Bristol Bay and the Proposed Pebble Mine

Facts and Circumstances

February 2020

Bristol Bay Native Corporation

The Tailings Dam Failure Example

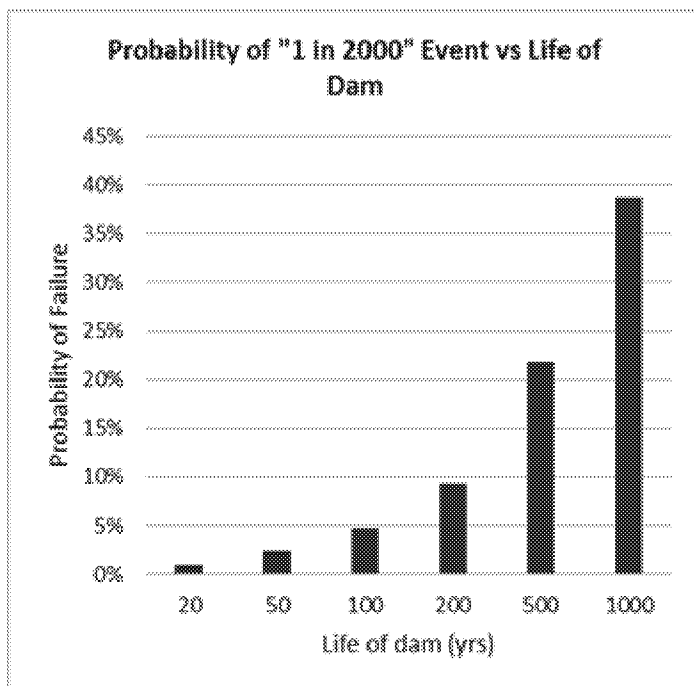
The Army Corps recently stated that it will not be conducting a full tailings failure scenario for the proposed Pebble Mine because (1) it “determin[ed] that a tailings dam breach would be a worst-case scenario and NEPA did not require assessing the impacts of it” and (2) “What this applicant is proposing are thickened tailings” that presumably are less subject to catastrophic failure.¹

The Corps’ decision not to do a failure scenario does not hold up to the science and the facts behind what PLP is proposing and is wrong on the law. It also ignores the fundamental yet missing information necessary for understanding, much less analyzing, PLP’s tailings dam proposals.

In a 2019 meeting with cooperating agencies about the tailings failure analysis, the State of Alaska, Lake and Peninsula Borough, Fish and Wildlife Service, and EPA all expressed concerns over the Corps’ refusal to analyze tailings dam failures and its impact on the public’s understanding of the risks of PLP’s proposal. According to notes from that meeting, the Corps at that point asked AECOM, the third-party contractor, how long such an analysis would take. AECOM responded that the analysis would take “several months.” The Corps asked no other questions.²
